Catchment Sensitive Farming Assessment Form

Applicant name	Ross Watson
Farm name and address	Hill Farm Partnership, Holmrook, CA19 1UG
CPH number	08.004.0180
SBI Number	200629398
Water Framework Directive Management Catchment	South West Lakes
River Basin District	North West
Form completed by: (CSFO or FaLMA supplier)	
Name	Rosie Law
Company if applicable	CSF
E mail address	[redacted]
Telephone number	[redacted]
Any additional comments	
Pollutant priorities and pressures:

Farm description: 480 cattle, 109ha, River Irt catchment, Freely draining slightly acid loamy soils, 100m to River Irt, 500m to Drigg Holme SSSI and 1.4km downstream to Drigg coast SSSI

Parcel ID: SD0799 7849

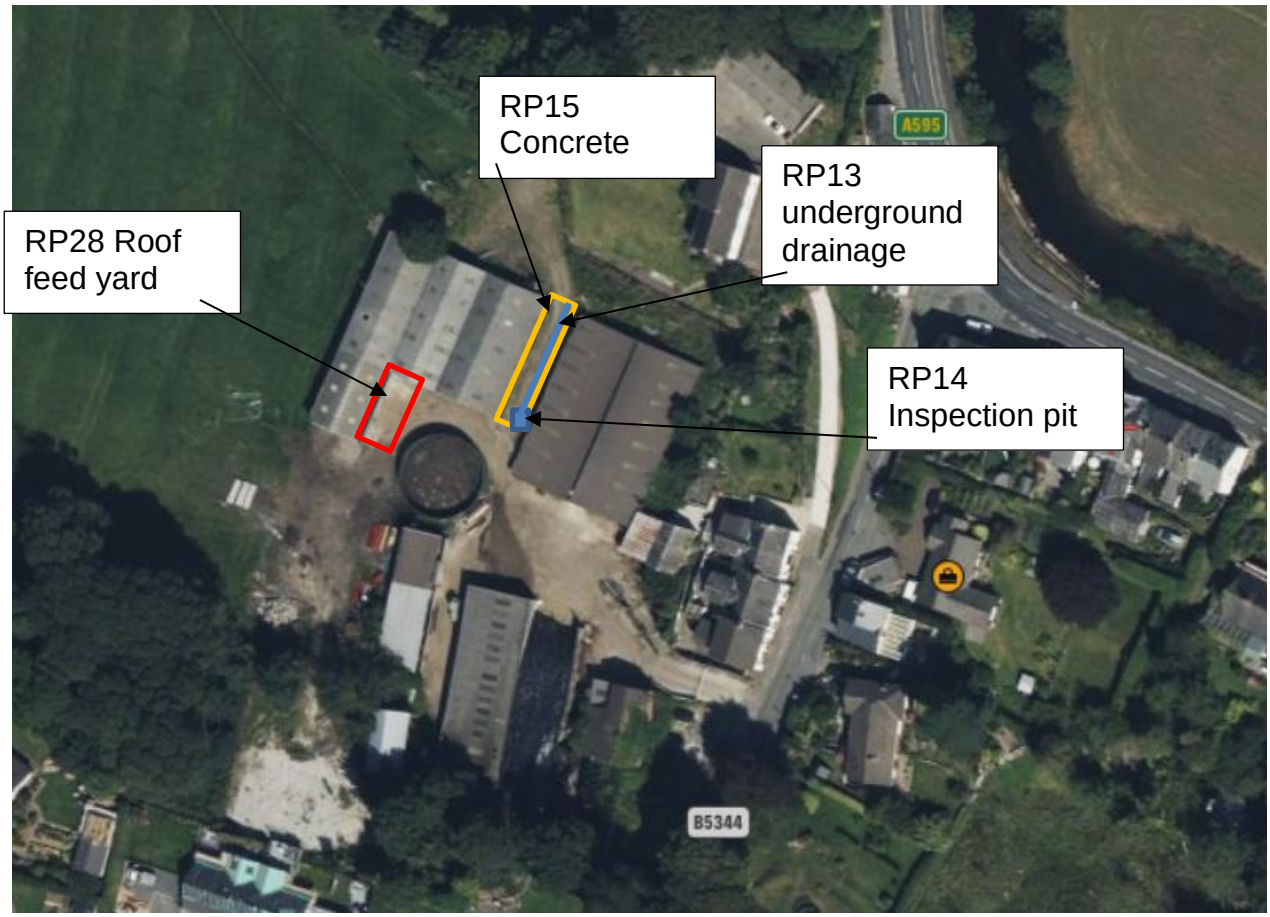
RP16- 346m

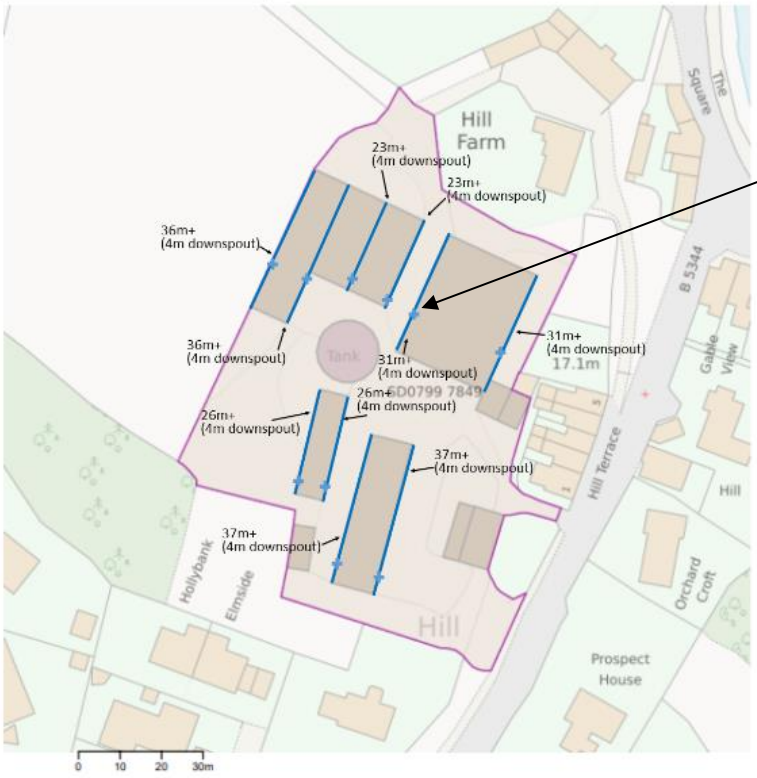
This downspout to be kept away from the corner to reduce chance of contamination from dirty water/slurry

- *Clean water from roofs to be collected in guttering and piped to appropriate storage or clean water drains/soakaways.*
- *The inspection pit is to have a solid cover to reduce the chance of dirty water/slurry from the adjoining dirty yard entering the clean drain*
- *The clean drain/downspout in the yard to be concreted should be part way up the yard and not on the corner next to the dirty yard as it is at present- this will avoid the chance of dirty water contamination of clean drains.*
- *The feed area next to the new concrete yard is to have kerb stones or profiled concrete so spilled feed is contained next to the building and not spoiling the new clean concrete*
